Access Compliance Report

Public Rights-of-Way

Intersection ID: 47113	Main Street: ELIZABETH_OAKS_AV	Cross Street: TINDLE_HILL_LN	Location: S
ADA ID: C32B3125B08C	Ramp Type: PerpDiag	Initial Pass/Fail: Fail	Overall Compliance: No
Severity Score: 61.25			
Codes/Mitigation Info/Possible Solution		Field Measurements/Component Compliance

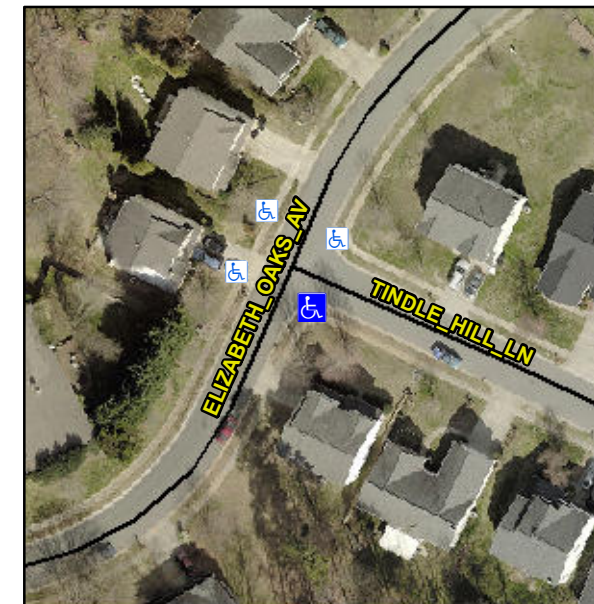
Not Found, R304.5.1, R304.2.2, R304.5.3, R302.7

Compliance	Description	Data	Compliance	Description	Data
N/A	Ramp Length (in)	46.5	No	Ramp Slope (%)	10.8
No	Ramp Width (in)	47.0	No	Ramp XSlope (%)	10.5
N/A	Flare Type LT	N/A	N/A	Flare Type RT	N/A
N/A	Flare Slope LT (%)	N/A	N/A	Flare Slope RT (%)	N/A
N/A	Flare Traversable LT?	N/A	N/A	Flare Traversable RT?	N/A
N/A	Landing Length (in)	N/A	N/A	DWS Provided?	N/A
N/A	Landing Width (in)	N/A	N/A	DWS Contrast?	N/A
N/A	Landing Slope (%)	N/A	N/A	DWS Length (in)	N/A
N/A	Landing X Slope (%)	N/A	N/A	DWS Full Width?	N/A
N/A	Landing Curb? (Y/N)	N/A	N/A	DWS Offset (in)	N/A
N/A	Shared Landing?	N/A			
N/A	Gutter Ponding?	N/A	N/A	Gutter Slope (%)	N/A
N/A	Gutter Lip Ht (in)	N/A	N/A	Gutter X Slope (%)	N/A
N/A	Painted X Walk1?	No	N/A	Painted X Walk2?	No
	X Walk 1 Direction	To NE		X Walk 2 Direction	To NW
N/A	X Walk 1 Width (in)	N/A	N/A	X Walk 2 Width (in)	N/A
	X Walk 1 Slope (%)	1.1		X Walk 2 Slope (%)	5.5
	X Walk 1 X Slope (%)	5.1		X Walk 2 X Slope (%)	3.8

Remove & Replace Curb Ramp With Two New Directional Ramps or Equivalent.
